## PRODUCT/PROCESS CHANGE NOTICE (PCN)

### ATTACHMENT I - PCN #: TB-0510-05

**PCN Type:** Packing/Shipping

#### New Shipping Tube

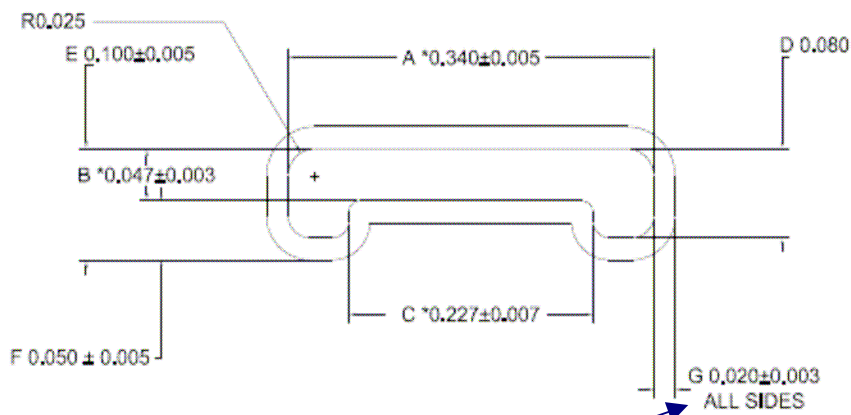
New Tube – wall thickness : 0.017 to 0.023

New Tube – printed revision, REV.07
